ADDENDUM 3

For
Cayce Utility Phase 1b

METROPOLITAN DEVELOPMENT AND HOUSING AGENCY
Nashville, Tennessee

August 23, 2022

DESIGNED BY:	
DRAWN BY:	
CHECKED BY:	
DATE:	06/16/2022
KIMLEY-HORN PROJECT NO.	118109018
ROADWAY PLAN AND PROFILE - S 7TH STREET	
SHEET NUMBER	C5-03

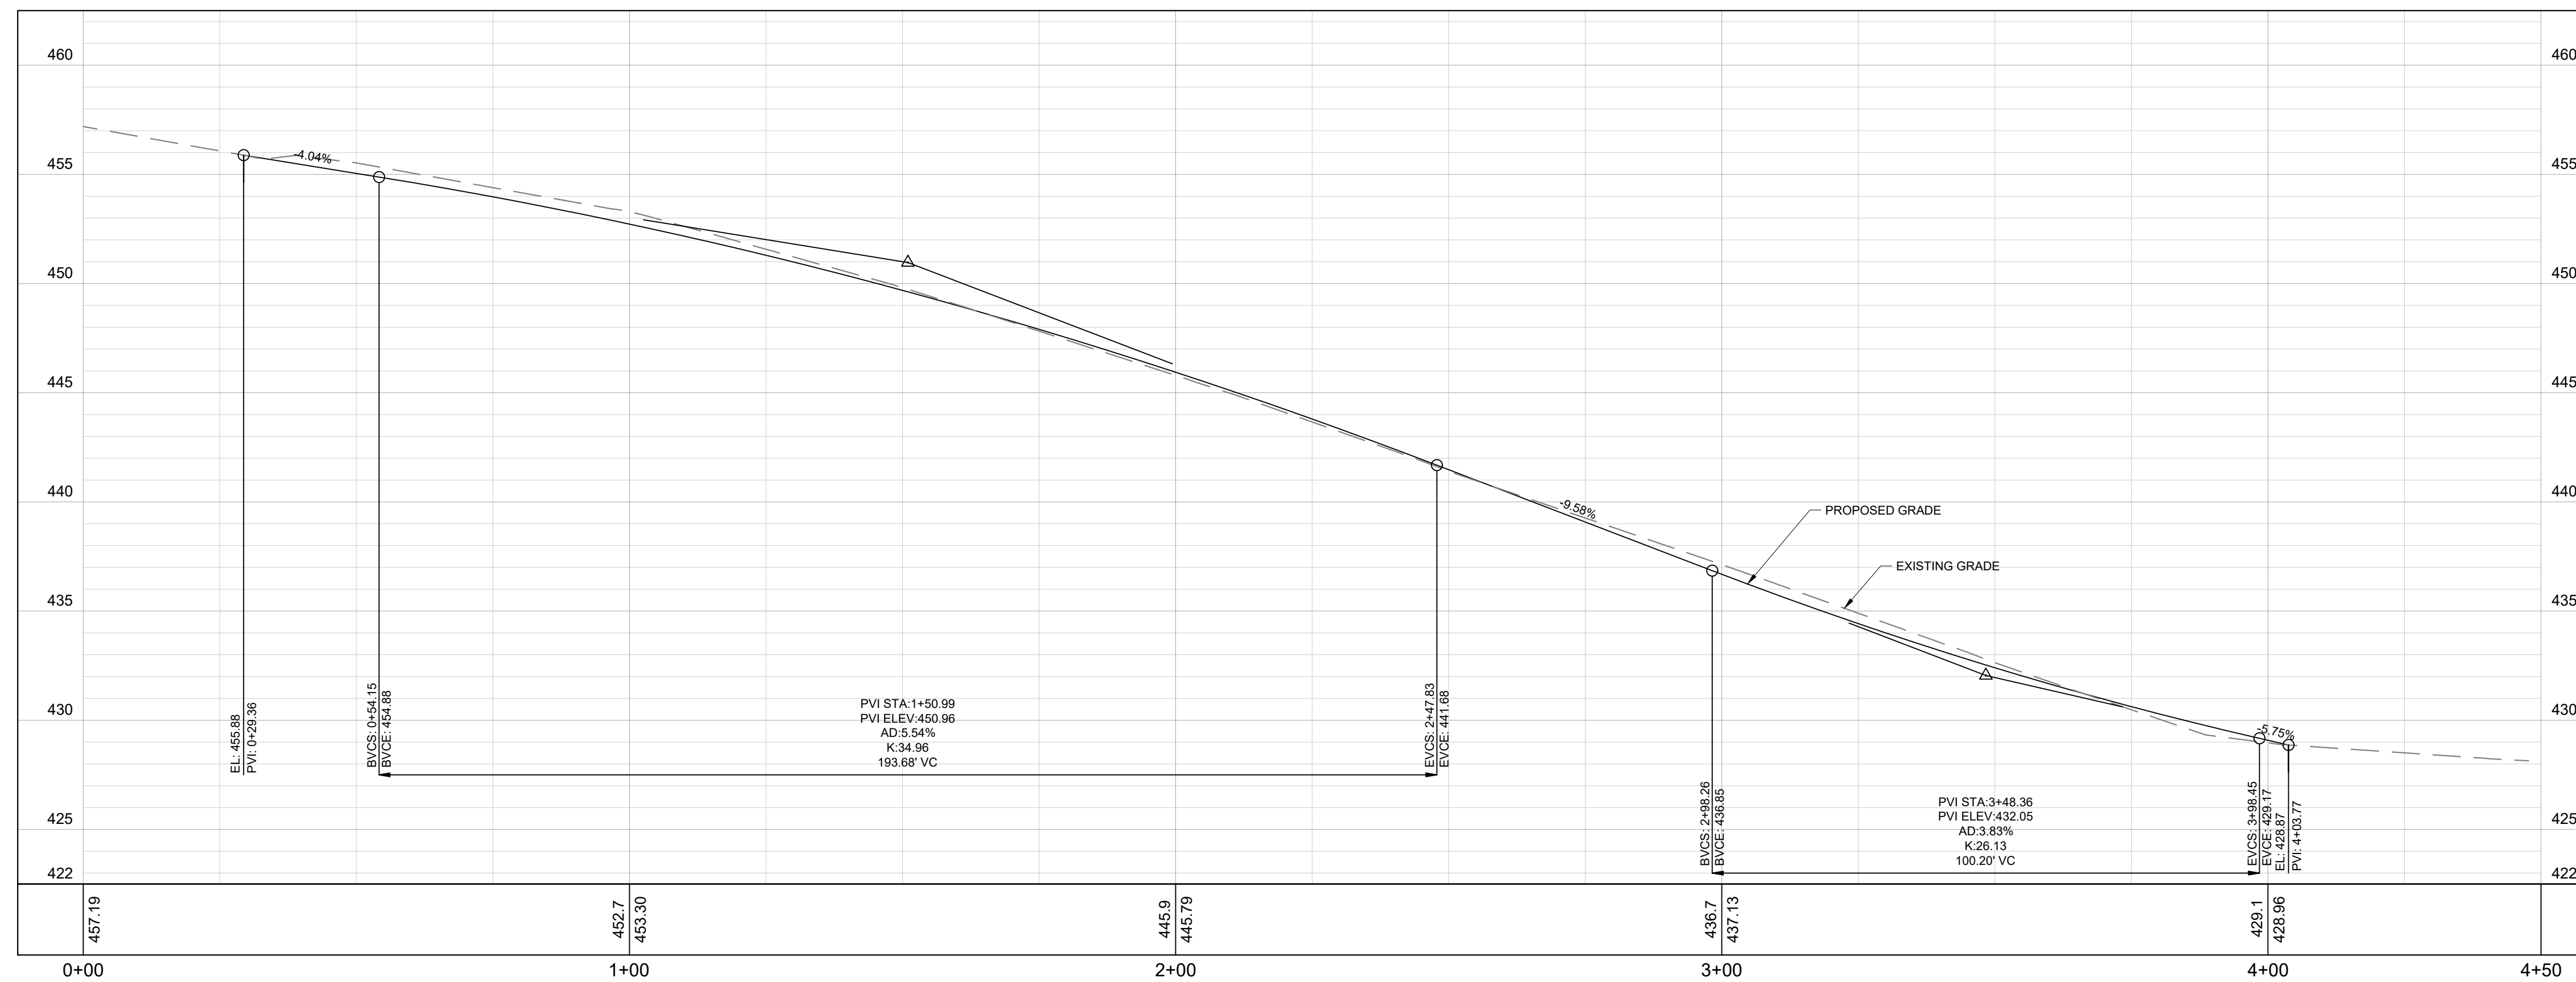
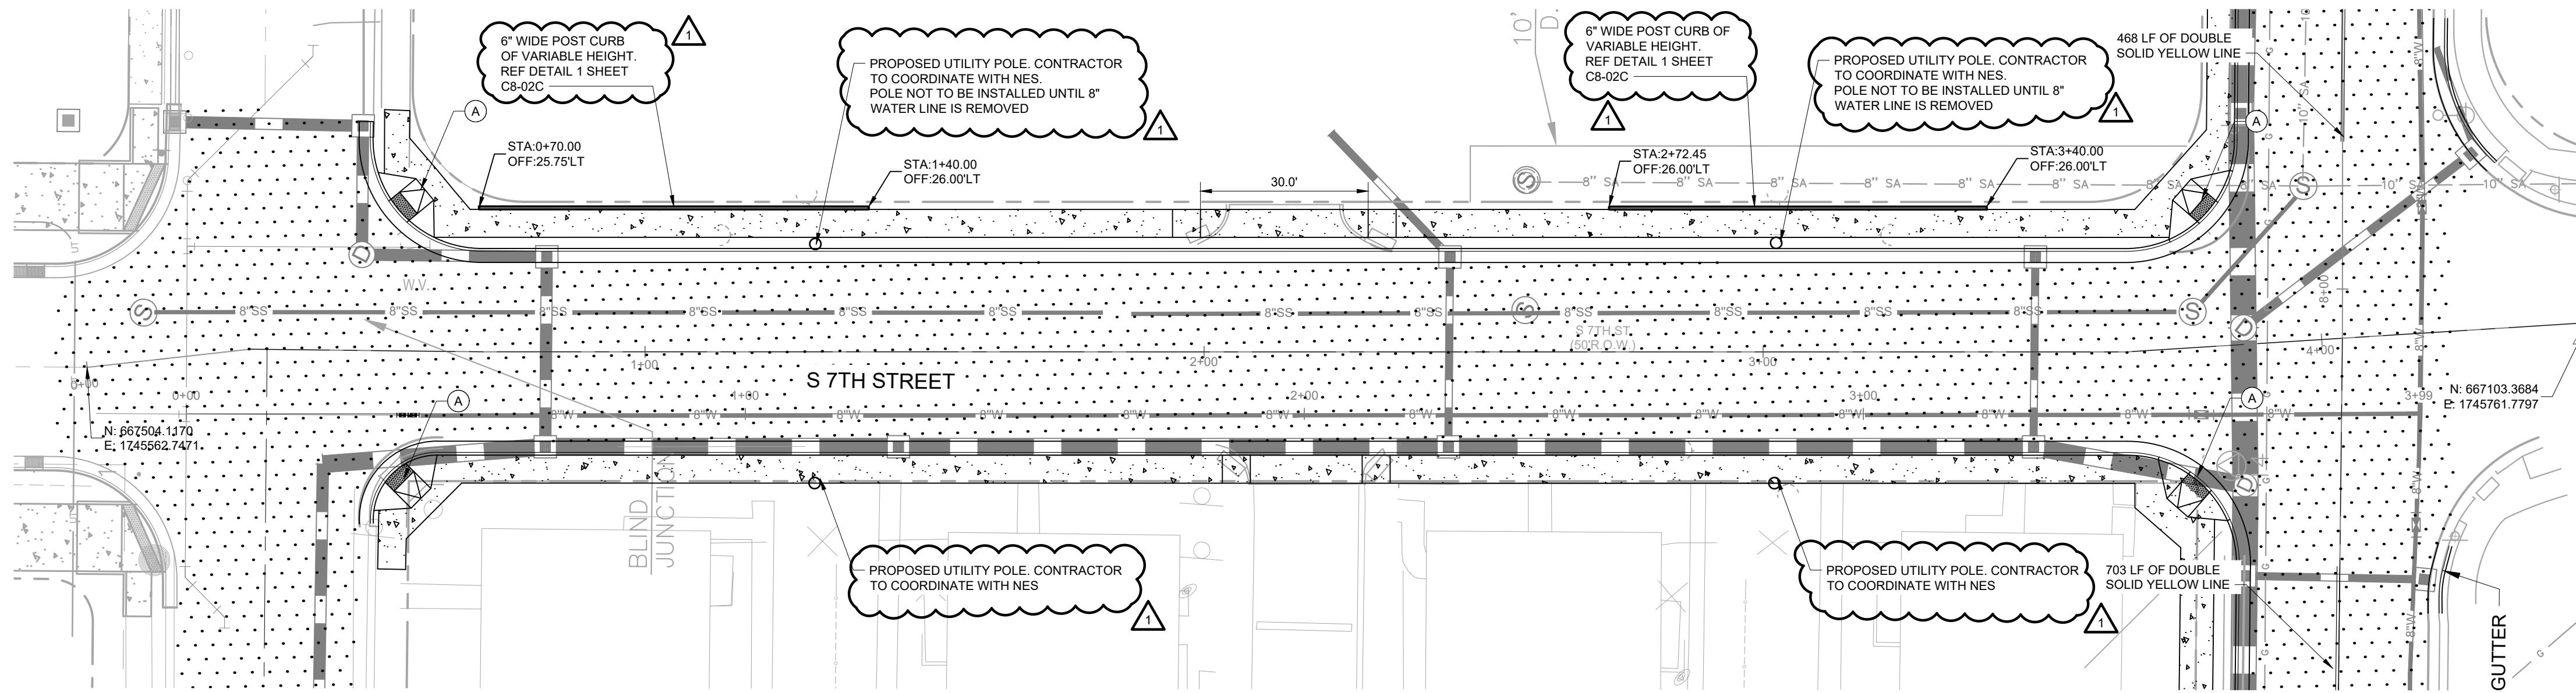
- Q15.** For the Concrete Turn Down Slab bid item. It is referenced to use the details on sheet C8-02C and Sheet C5-03 for locations. on Sheet C8-02C the only details are for detectable warnings at curb returns. These details correlate with keynote A in the legend on sheet C5-03. This appears to be a separate item that the length of turn down slab on the plans. Will you please provide the details for this bid item or specify how these relate?

- A15.** Sheet C5-03 has been revised to denote a curb at the back of the sidewalk instead of a turndown. The detail has been added to Sheet C8-02 to show the curb at the back of the sidewalk. Curb heights can be seen on the cross-section drawings. Please continue to utilize Item #920-10.01 for this item measured in LF. The average height of this curb above grade is 6" on the northern section that is 70 LF and average of 11" on the southern section is that 70 LF. So, the bid item should be based on 140 LF of curb with an average height above grade of 8.5".
